PROJECT
THREE STOREY RESIDENTIAL FLAT BUILDING
WITH BASEMENT CAR PARK AT:
**5 COMMONWEALTH PDE,
MANLY, NSW**

DRAWING TITLE			PROJECT
SITE ANALYSIS PLAN			CPM
SCALE	STATUS	NUMBER	REVISION
1:500 @A3	s4.55	A0.01	s4.55

LIST OF AMENDMENTS

DRAWING TITLE
WEST ELEVATION

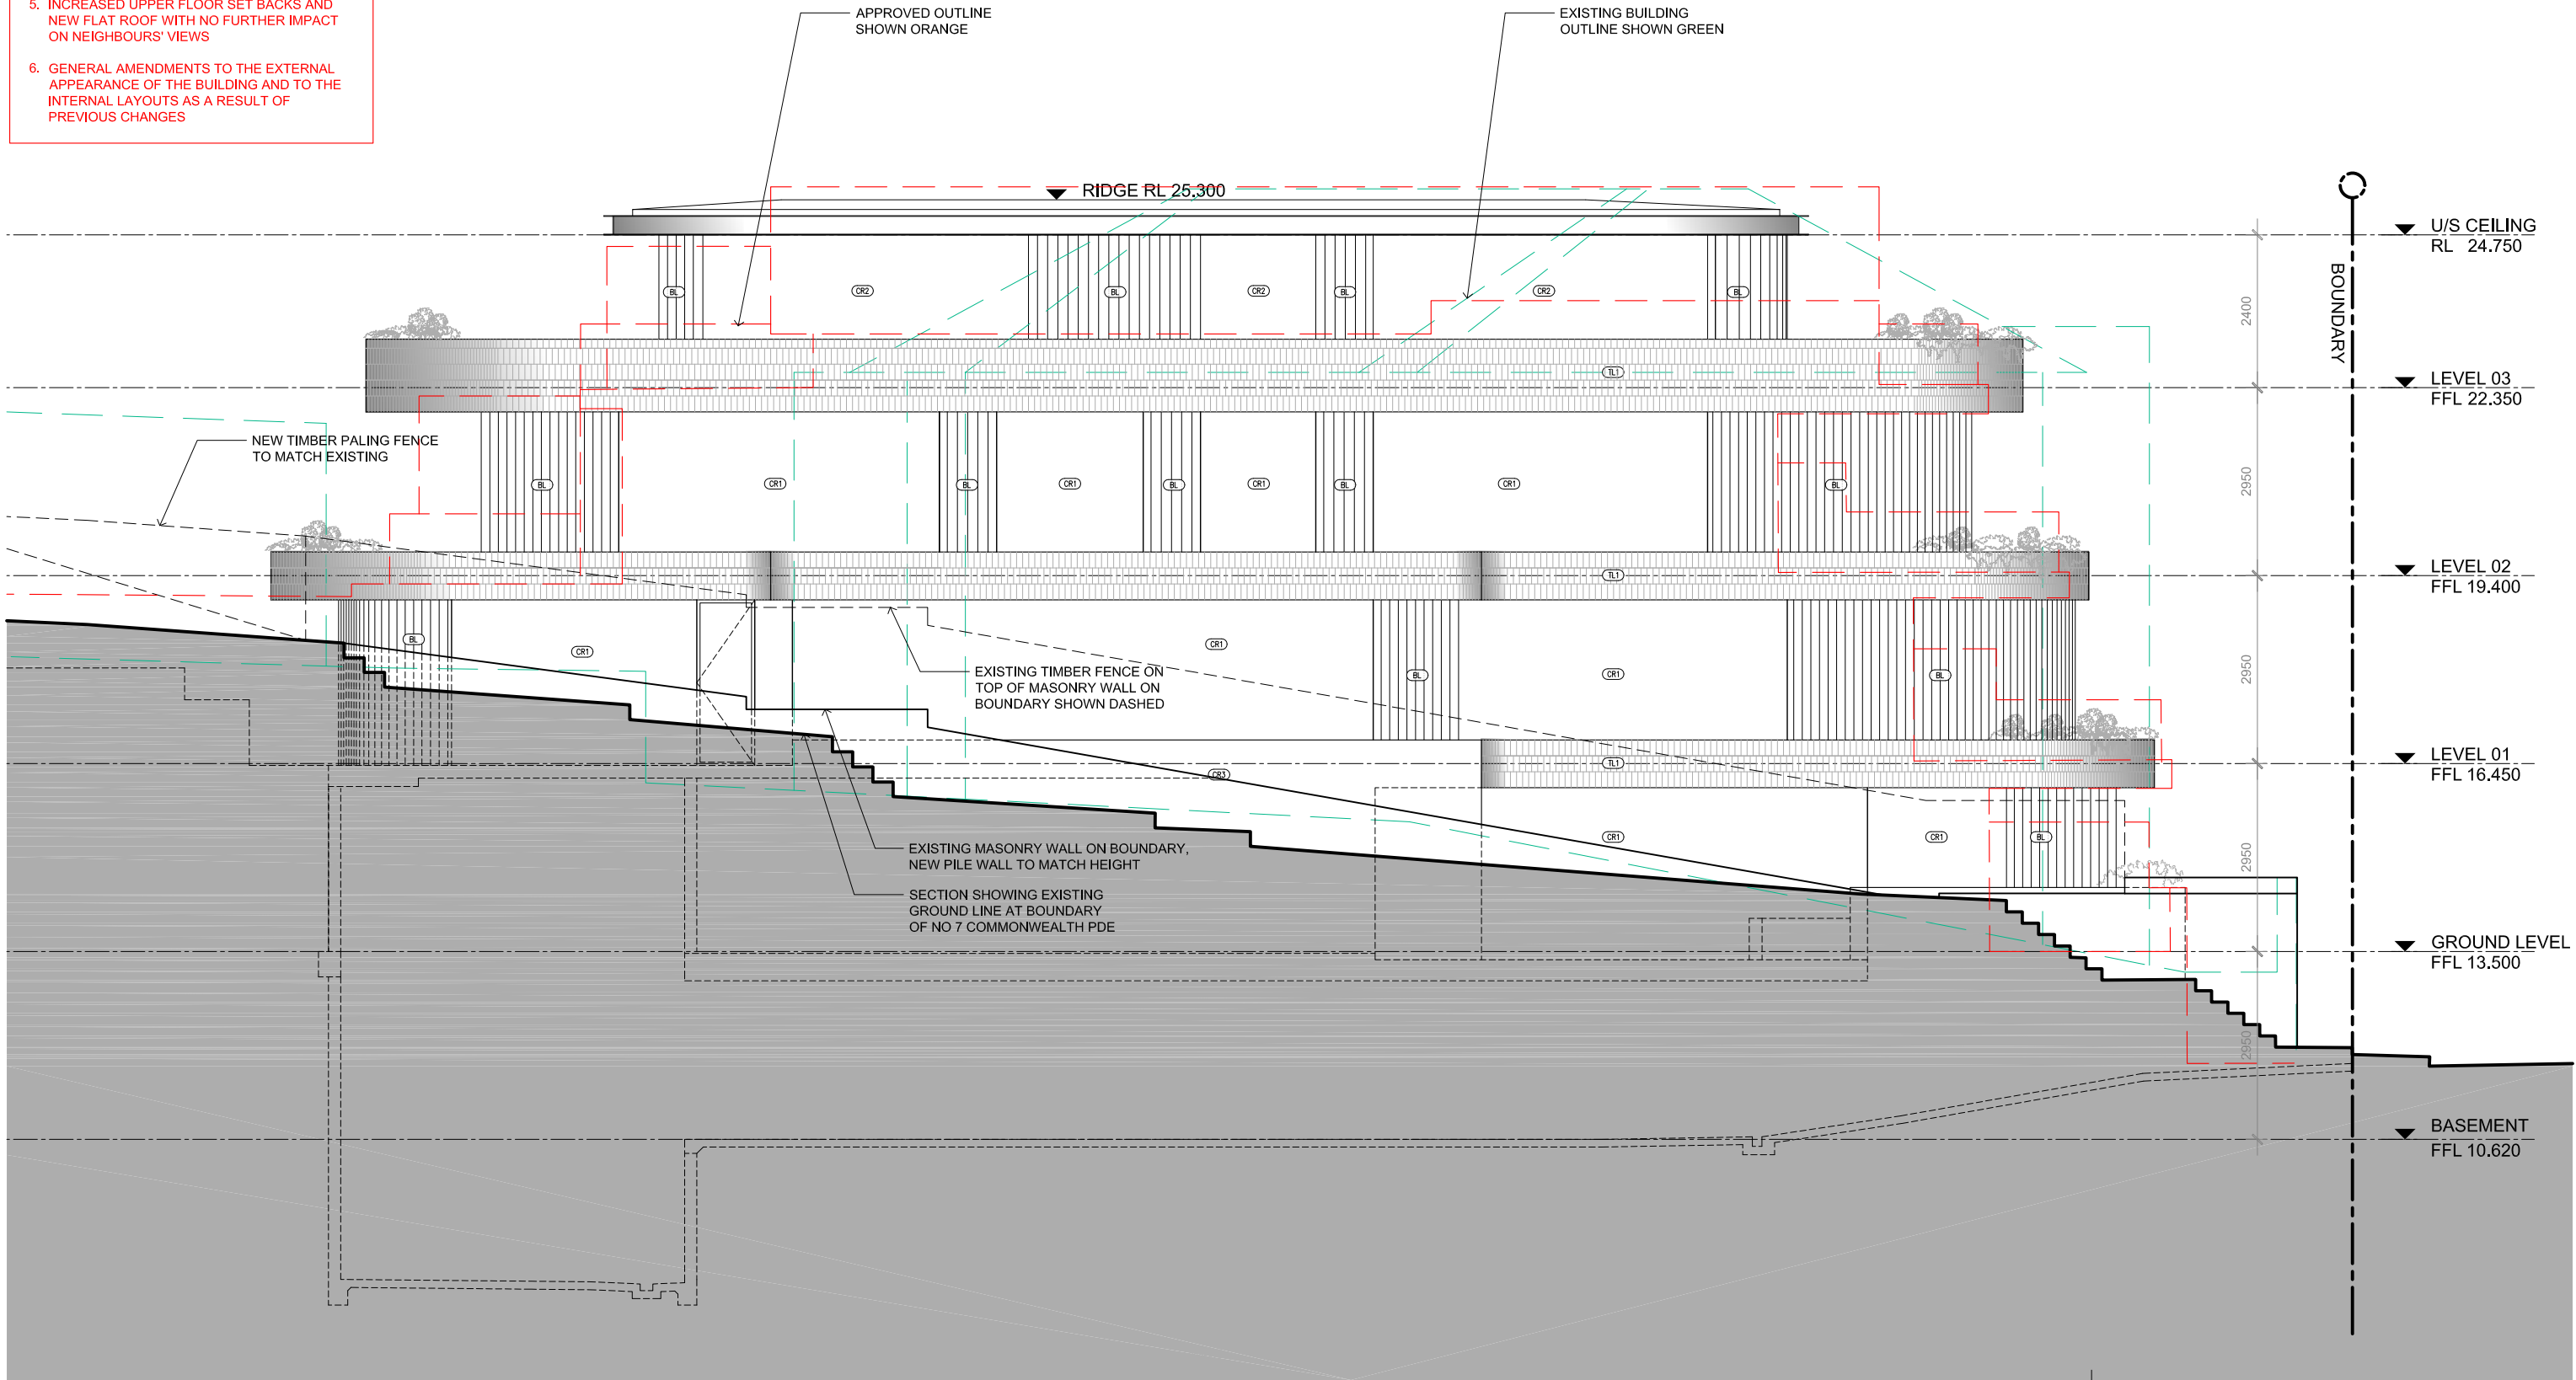
1. PREVIOUS SURVEY WAS NOT SET OUT TO AHD, ALL RLS ADJUSTED TO SUIT NEW SURVEY
2. ADJUSTMENTS TO RAMP AND CAR STACKER TO COMPLY WITH REGULATIONS & AS2890.1
3. GREENERY & PRIVACY TREATMENTS INCORPORATED INTO THE BUILDING DESIGN TO ADDRESS PRIVACY AND IMPROVE AMENITY
4. RECONFIGURATION OF THE CORE
5. INCREASED UPPER FLOOR SET BACKS AND NEW FLAT ROOF WITH NO FURTHER IMPACT ON NEIGHBOURS' VIEWS
6. GENERAL AMENDMENTS TO THE EXTERNAL APPEARANCE OF THE BUILDING AND TO THE INTERNAL LAYOUTS AS A RESULT OF PREVIOUS CHANGES

DRAWING TITLE
SOUTH ELEVATION

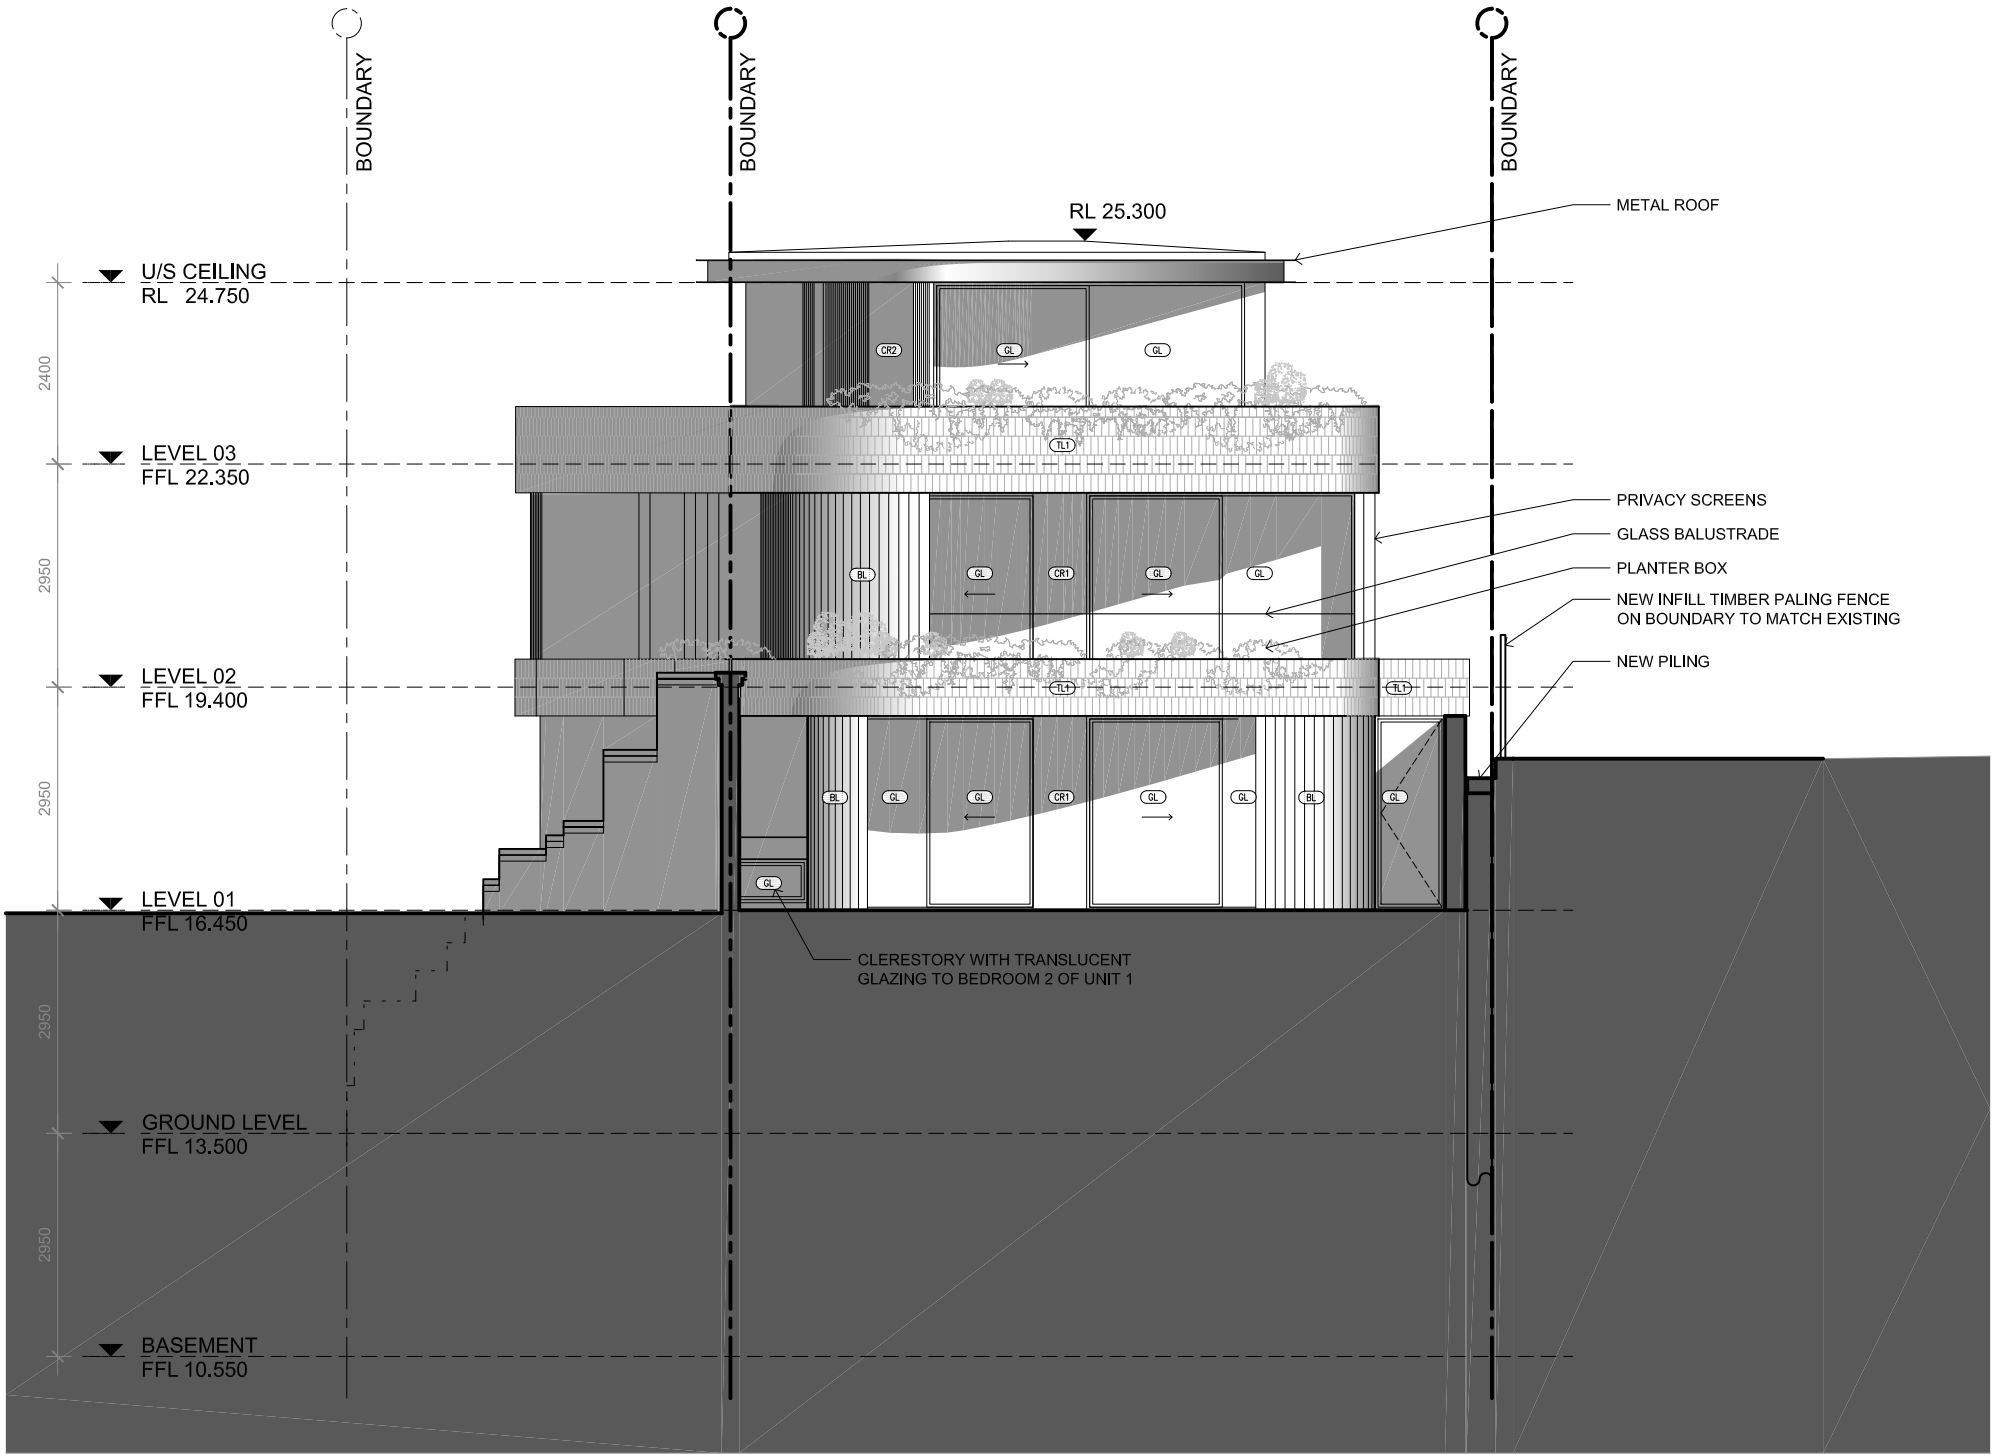
1. PREVIOUS SURVEY WAS NOT SET OUT TO AHD, ALL RLS ADJUSTED TO SUIT NEW SURVEY
2. ADJUSTMENTS TO RAMP AND CAR STACKER TO COMPLY WITH REGULATIONS & AS2890.1
3. GREENERY & PRIVACY TREATMENTS INCORPORATED INTO THE BUILDING DESIGN TO ADDRESS PRIVACY AND IMPROVE AMENITY
4. RECONFIGURATION OF THE CORE
5. INCREASED UPPER FLOOR SET BACKS AND NEW FLAT ROOF WITH NO FURTHER IMPACT ON NEIGHBOURS' VIEWS
6. GENERAL AMENDMENTS TO THE EXTERNAL APPEARANCE OF THE BUILDING AND TO THE INTERNAL LAYOUTS AS A RESULT OF PREVIOUS CHANGES

DRAWING TITLE
SECTION BB

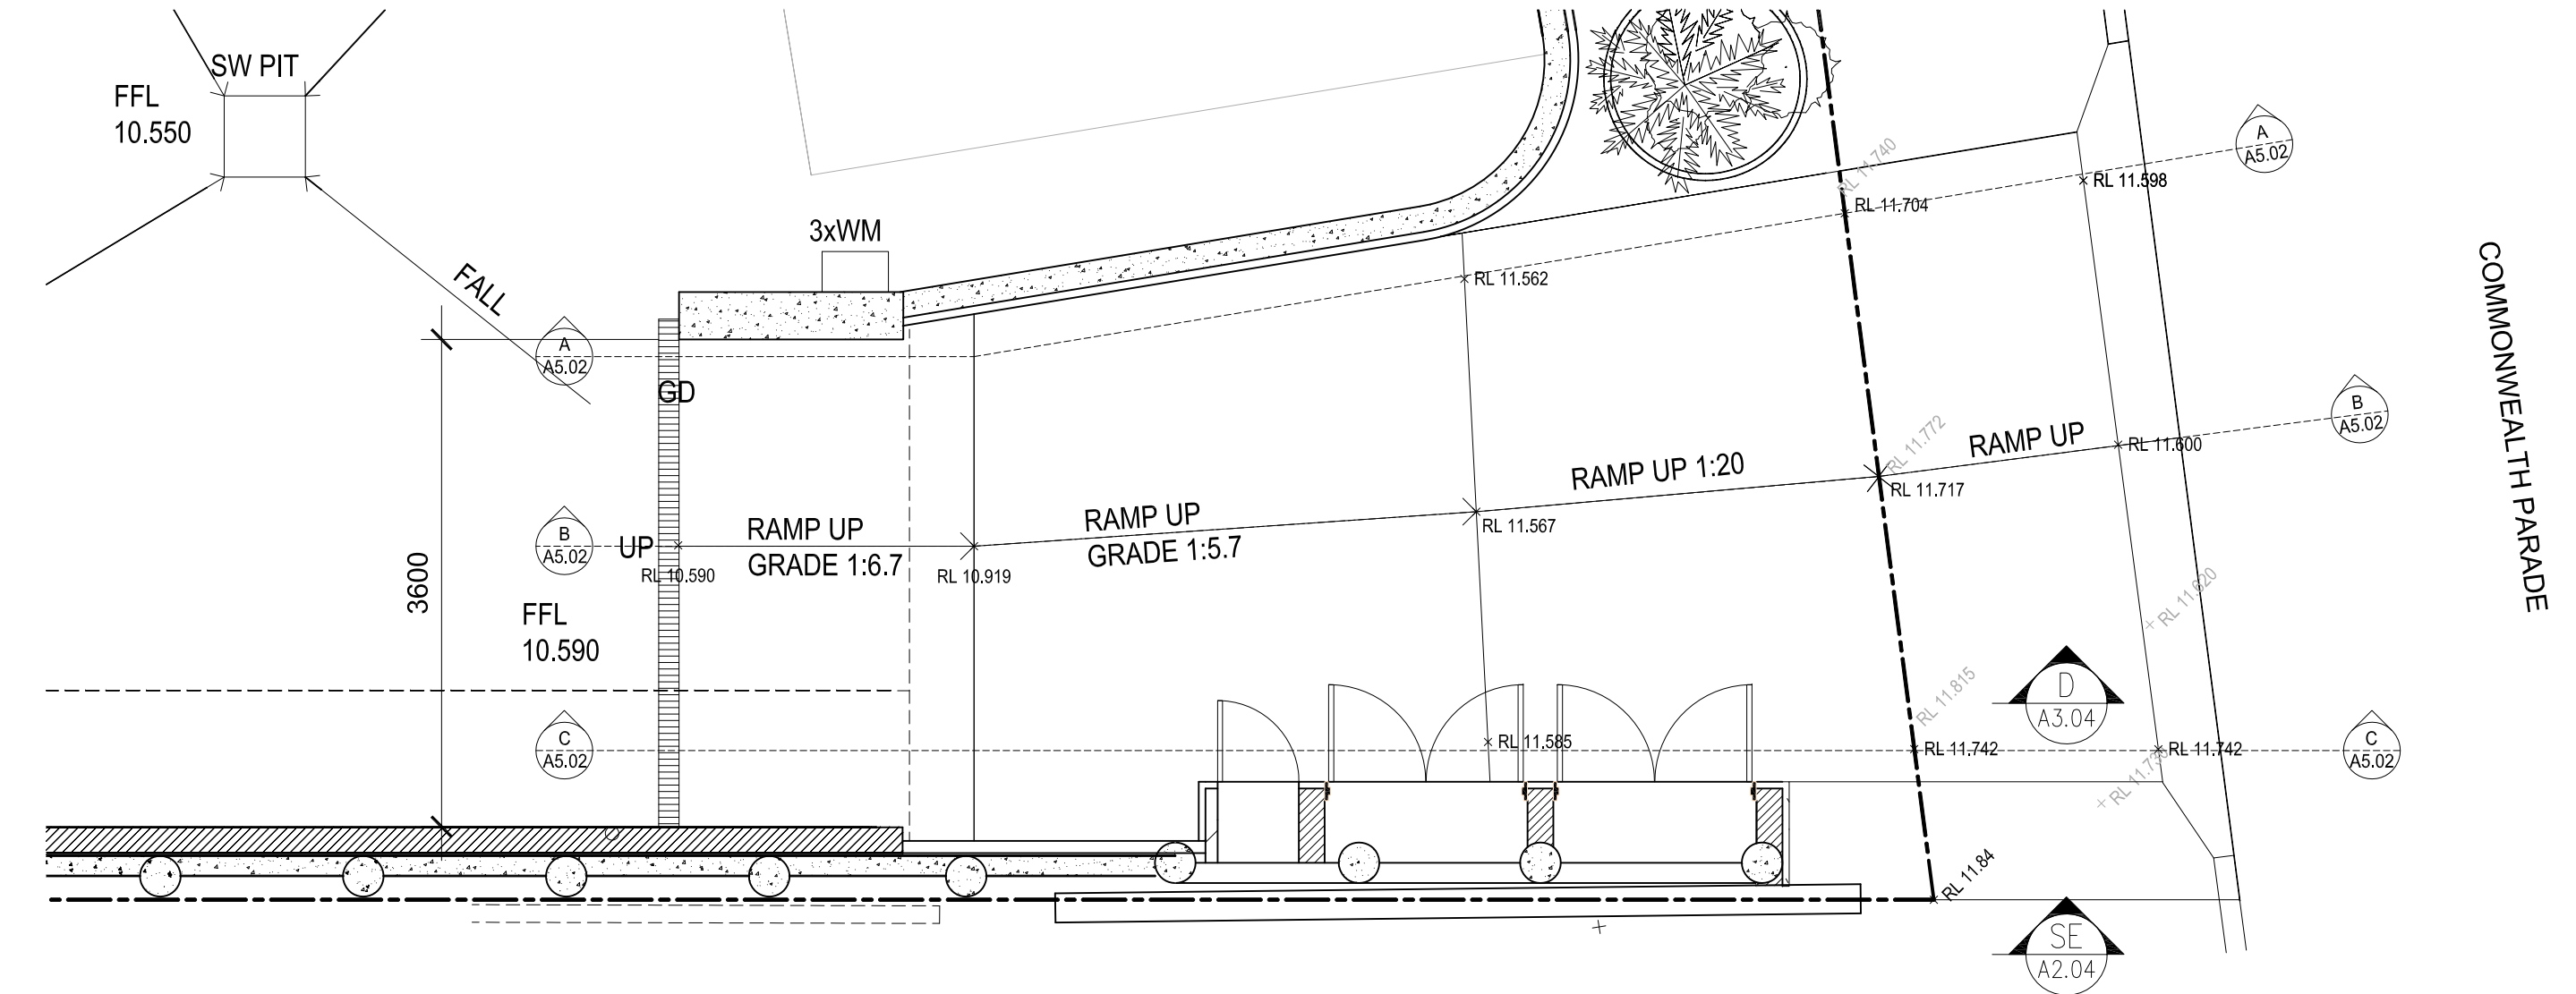
1. PREVIOUS SURVEY WAS NOT SET OUT TO AHD, ALL RLS ADJUSTED TO SUIT NEW SURVEY
2. ADJUSTMENTS TO RAMP AND CAR STACKER TO COMPLY WITH REGULATIONS & AS2890.1
3. GREENERY & PRIVACY TREATMENTS INCORPORATED INTO THE BUILDING DESIGN TO ADDRESS PRIVACY AND IMPROVE AMENITY
4. RECONFIGURATION OF THE CORE
5. INCREASED UPPER FLOOR SET BACKS AND NEW FLAT ROOF WITH NO FURTHER IMPACT ON NEIGHBOURS' VIEWS
6. GENERAL AMENDMENTS TO THE EXTERNAL APPEARANCE OF THE BUILDING AND TO THE INTERNAL LAYOUTS AS A RESULT OF PREVIOUS CHANGES
